Prepared for St. Luke's Grammar School
September 2020

SSDA Response to Submission (RTS)

New Senior School Campus

800 Pittwater Road, Dee Why NSW 2099

Proposed Column Interpretation

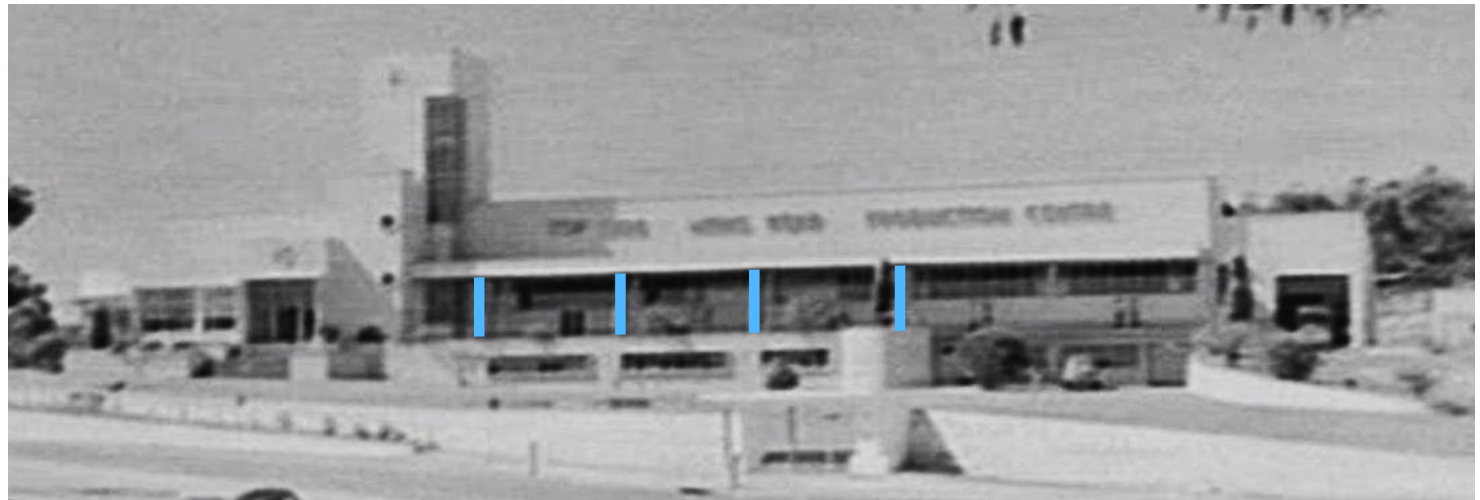
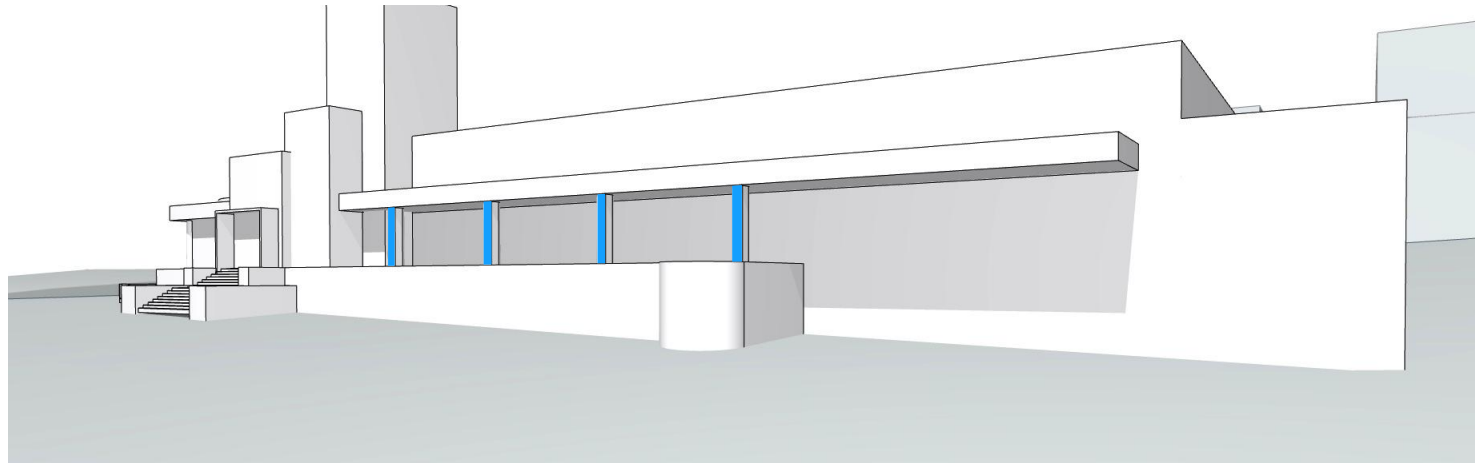
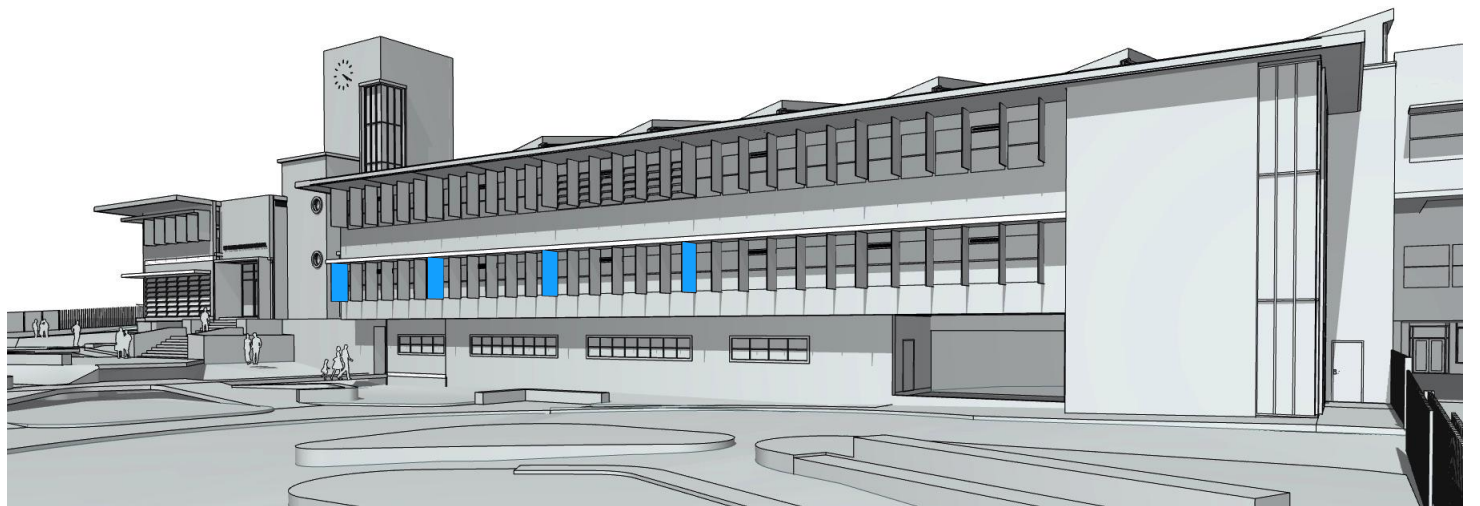
The new design fails to interpret the solidity and fenestration pattern of the original facade. The existing glazing on the western facade is proposed to be replaced with a new facade of solidity and fenestration which is not a lot different than the existing in terms of the location of the external walls. The original facade was located behind the leading edge of the clock tower with a parapet and recessed upper storey facade as well a large overhang. Similarly, the area to the left of the main entrance was also behind the leading edge of the tower. This original design ensured that the asymmetrical clock tower and building entrance took prominence as part of the original design, which has been lost in later additions. While the proposal does adopt a strong horizontal architectural statement, by adopting the line of the current Officeworks building for its new walls and large overhangs, this component will continue to

The original collonade columns were replaced by taller columns to support the new Western facade.

The proposal is to interpret the original collonade columns by larger shading fins to mark the original location of the columns. The enlarged shading fins (highlighted in blue) are integrated in the array of shading fins along the new fenestration bands of the western facade.

The proposed colour is a deep blue to enable the enlarged shading fins to stand out from the adjoining slimmer shading fins. The colour of the remaining fins is an array of toned down blues to respond to the school colours as used at the School Campus on 210 Headland Road (also refer Materials and Finishes, pg.17).

Proposed size of skylight

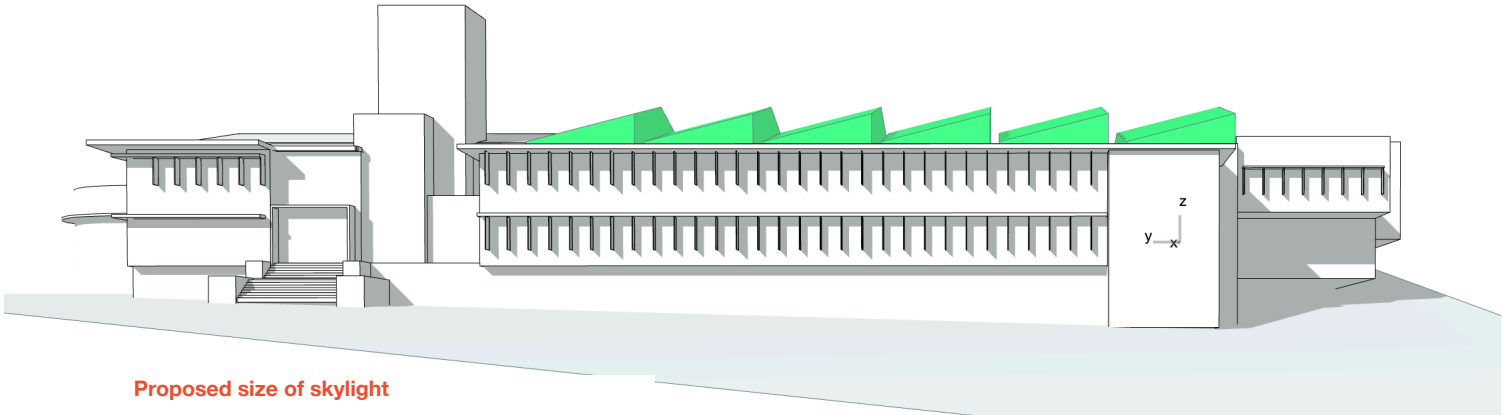
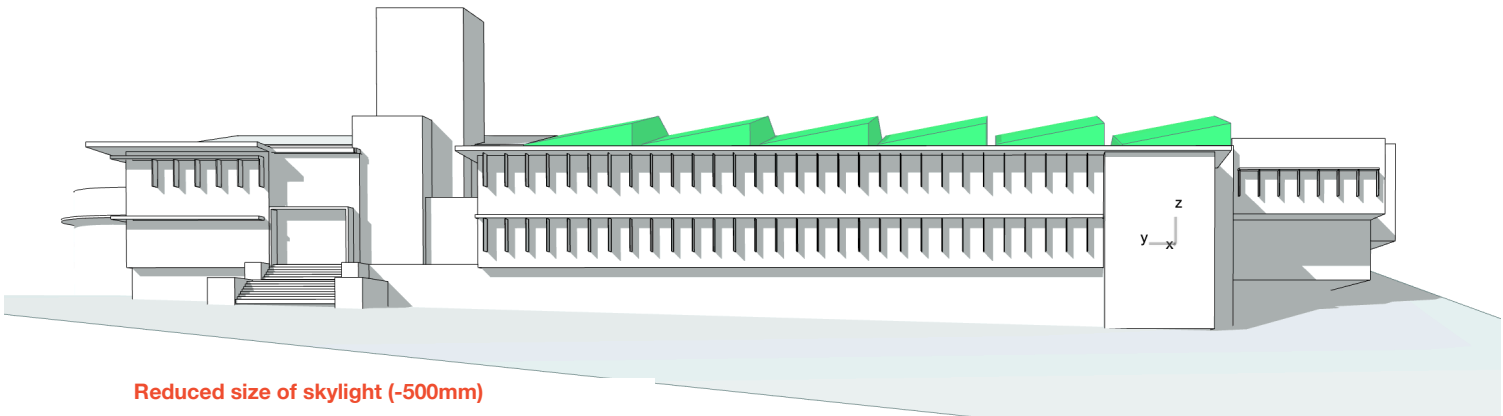
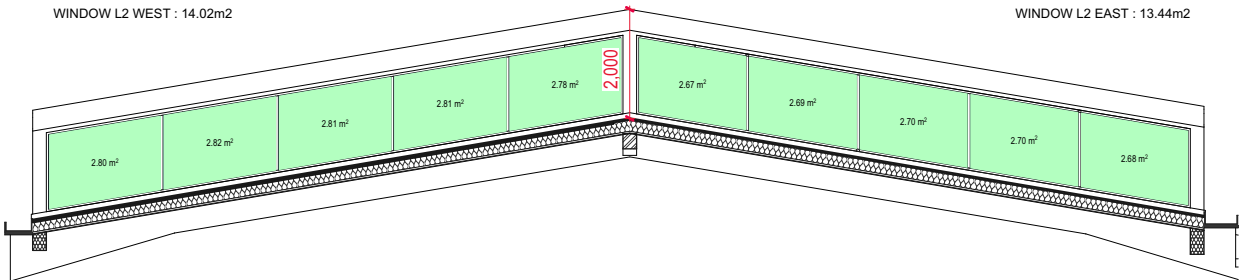
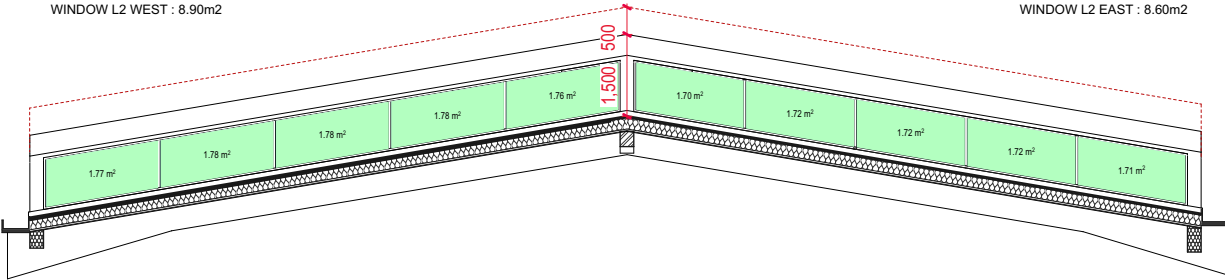
The proposed roof form incorporating sawtooth roofs is acceptable from a heritage perspective as they will provide natural light into the central area of the building without compromising the facade treatment. However, it would be preferable if the height of the sawtooth roof was reduced, to minimise its visibility on the western facade, as the original roof was not readily visible above the original parapet.

The size of the saw tooth roof was established by balancing the visual impact of the new pop-out structures with the natural light levels required in the general learning and the large communal areas. A full daylight analysis was undertaken to ensure BCA compliance for natural light levels in educational establishments.

The proposed skylight extends 2 metres above the current ridge line and provides 27.47m2 of clear glass area.

To test the visual impact and the resulting reduction in light levels for the reduced height skylights an arbitrary number of 500mm in height reduction was investigated. Any further reduction in size would make the skylights non-functional

The reduced size skylights extend 1.5 metres above the current ridge line and provide 17.50m2 of clear glass area. This is an reduction of more than 36% in clear glass area. To establish the resulting lux levels a new daylight analysis would need to be carried out. The currently proposed light levels are already at their minimum and a further reduction would result in the non-compliance of 6 GLA's (General Learning Areas) and reduced light levels in 3 Flexible Learning areas, 2 Learning Hub's, the Library and the Atrium on level 1.

We conclude that the visual benefit of reducing the height of the skylight does not outweigh the loss in amenity and code non-compliance for the internal spaces. We believe that the skylights add character and are reminiscent of the industrial past of the building, interpreting the original roof form.

Proposed West Elevation - Signage promoting "ST. LUKE'S GRAMMAR"

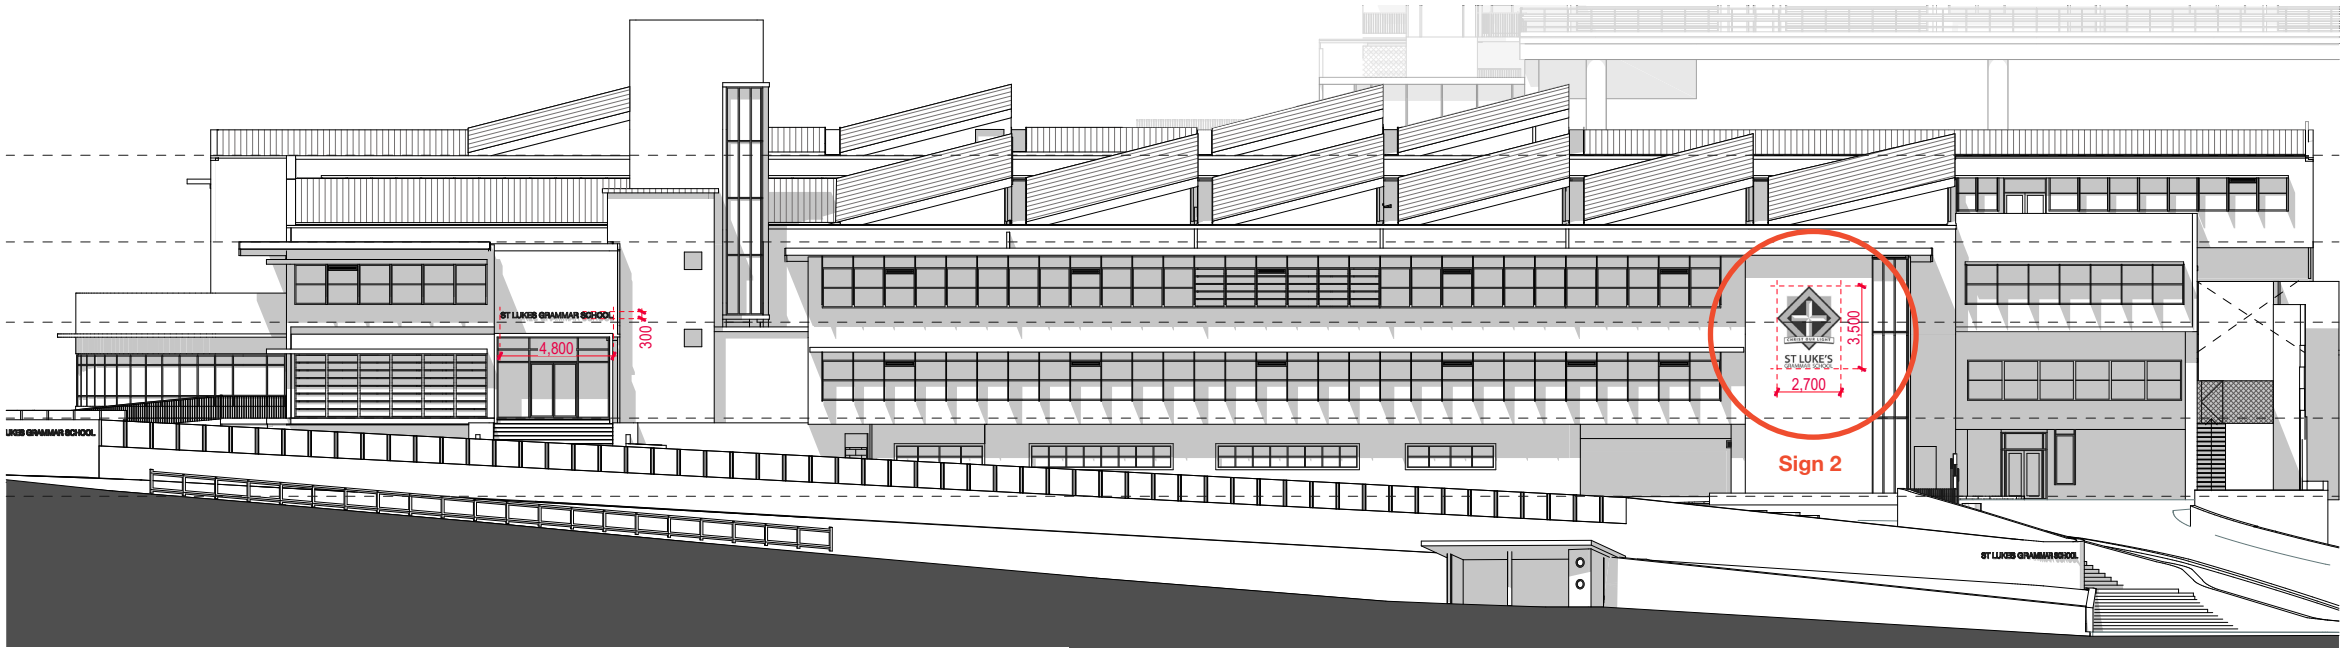
Proposed signage is generally acceptable. However, consideration should be given to a reduction in the size of proposed Sign 2, the main sign on the southern end of the front facade, so that it does not dominate the facade and compete with the heritage clock tower.

The proposed ST. LUKE'S GRAMMAR signage occupies a significantly smaller area of the western building facade than any previous signage, including the original TOP DOG MEN'S WEAR signage, the later BOND'S signage and the current OFFICE WORKS and FITNESS FIRST signage.

We have considered the size reduction of Sign 2 and advise that it does not dominate the facade or compete with the heritage clocktower. The current size is the minimum size required for legibility from Warringah road and Pittwater Road.
